CITY OF ALBUQUERQUE

RE: MIRA MESA SUBDIVISION, (J-10/D40)
Engineers Certification for Release of Financial Guaranty
Engineers Stamp dated 09/30/2004
Engineers Certification dated 12/27/2005

RE: Storm inlet detail for Mira Mesa Subdivision- to be installed in Glenrio Street

Re: Mira Mesa Subdivision Drainage Report
Engineer's Stamp dated 9-30-04 (J10/D40)

STORM INLET DETAIL

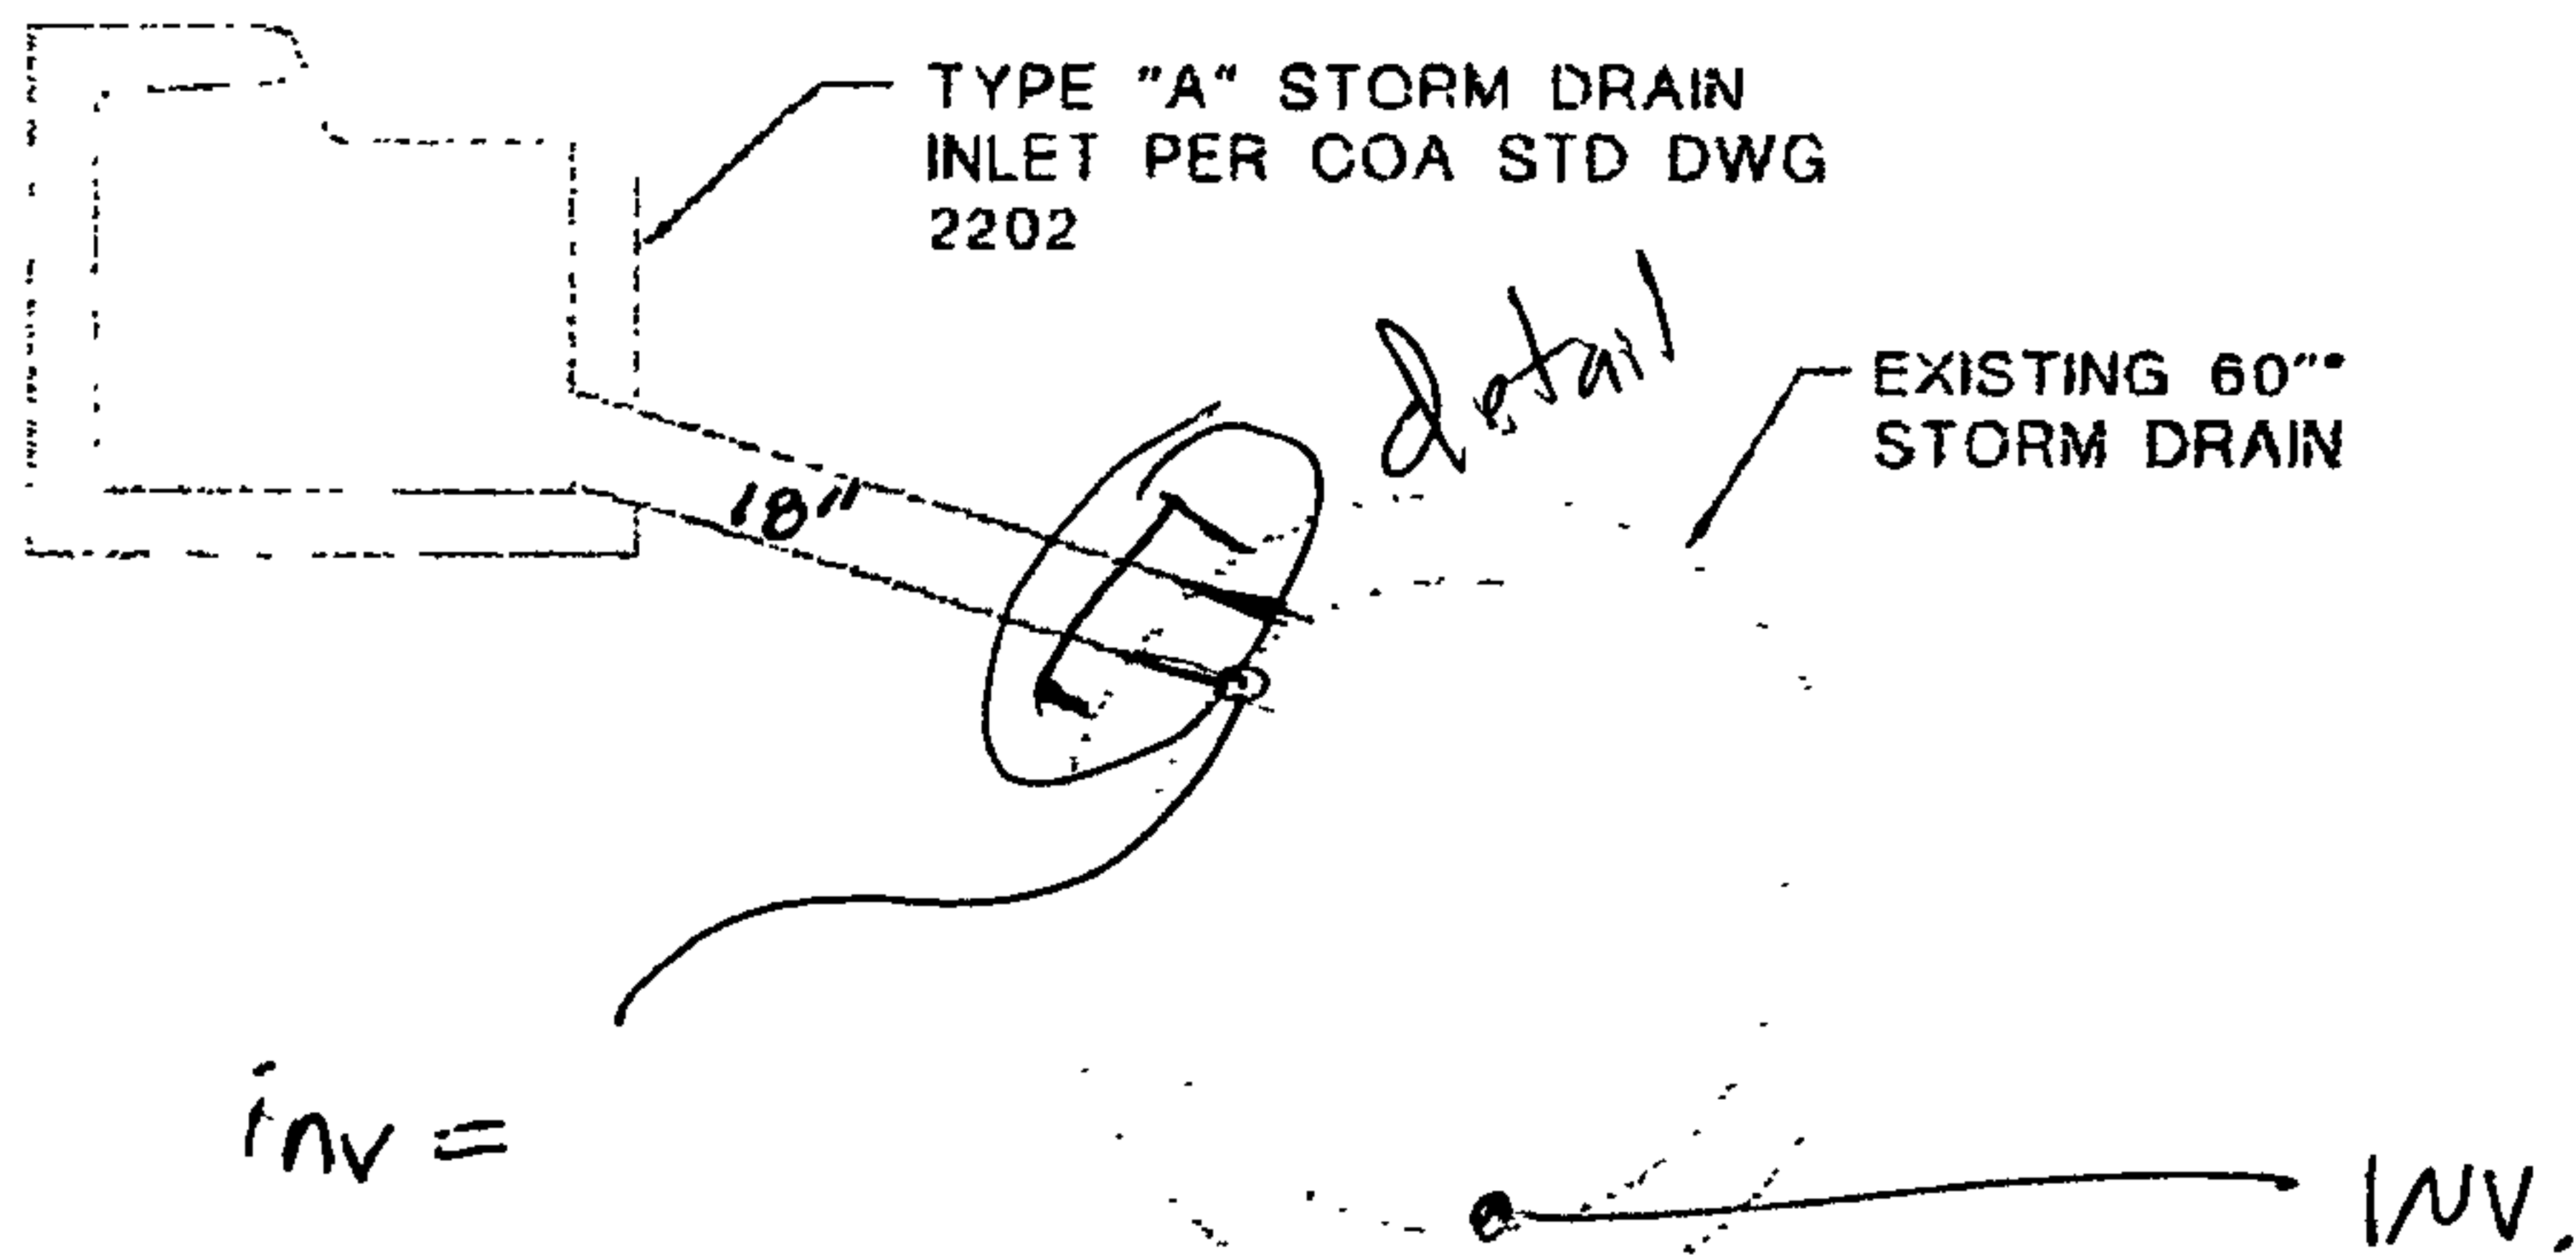
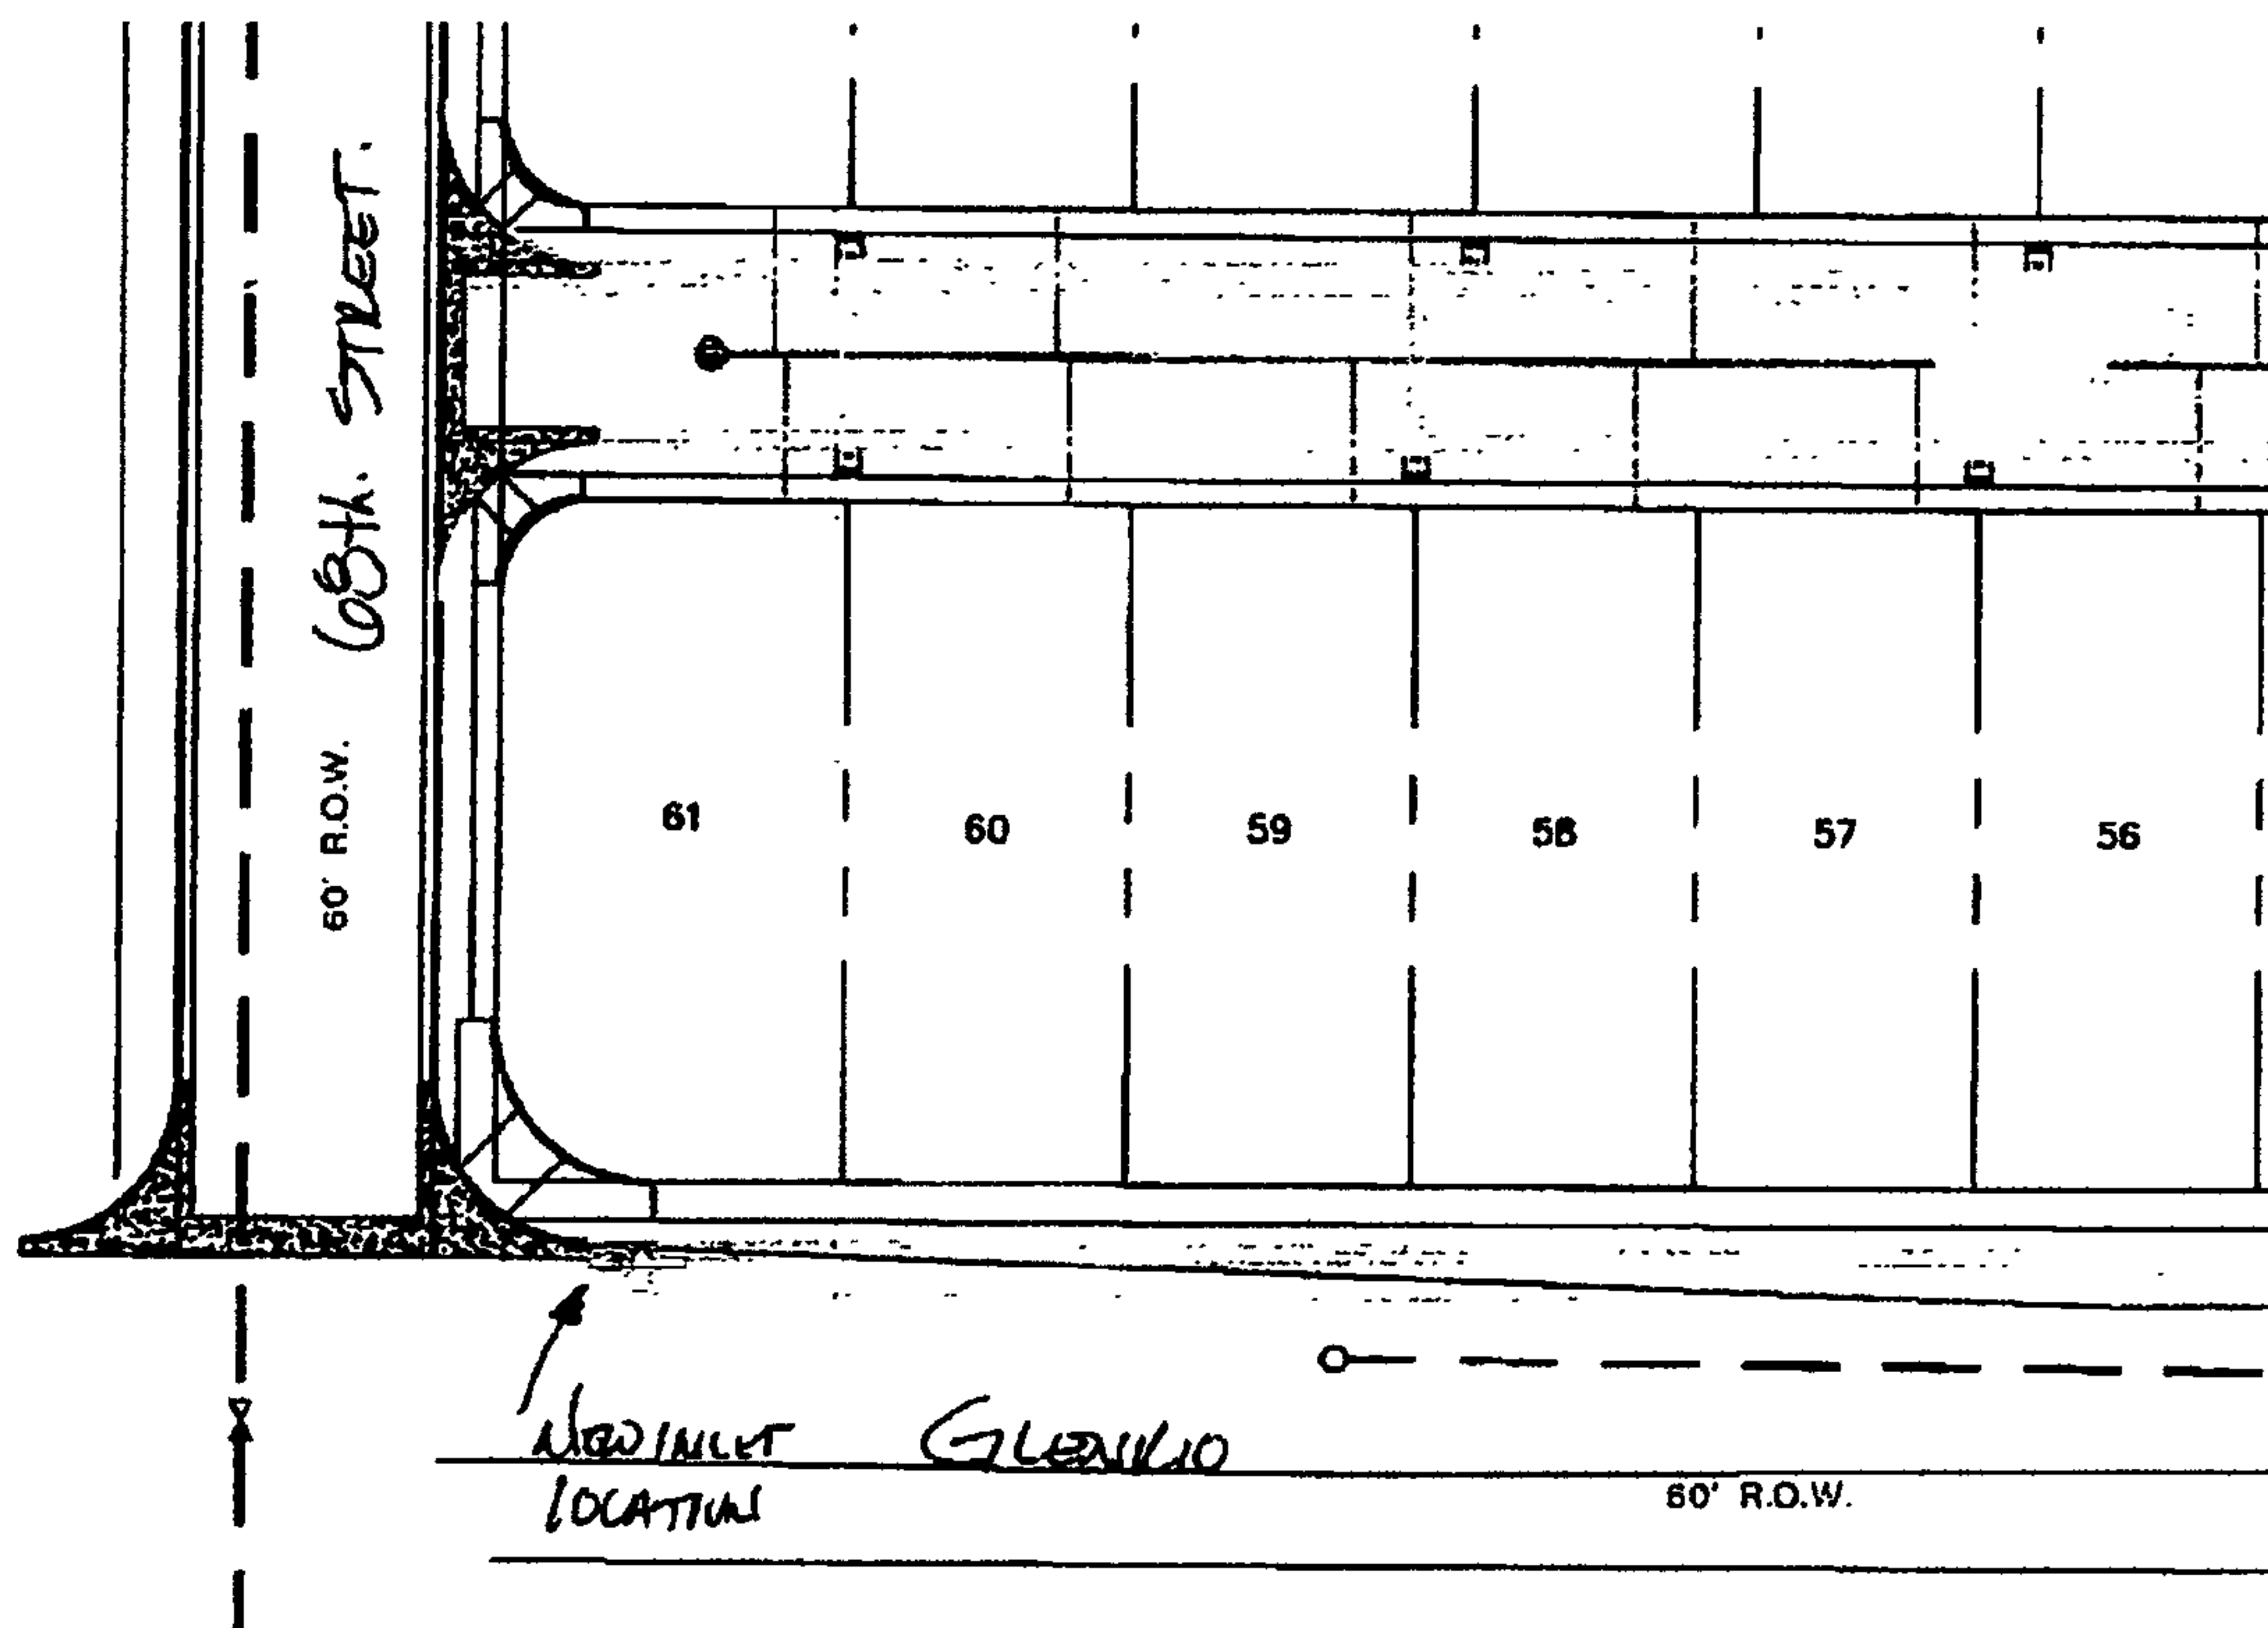
The follow detail is proposed to be used to install the required curb inlet on Glenrio at 68th Street as part of the Mira Mesa Subdivision project. As you and I have discussed, a single "A" inlet with an 18" pipe connected directly into the existing storm drain will be acceptable.

After further discussion with Mr. Jim Pung of the DRC staff, he has asked me to get your approval in writing prior to having him approve and the contractor install the inlet. I have enclosed a copy of the detail given to the contractors for pricing. Please review and approve this detail as soon as possible.
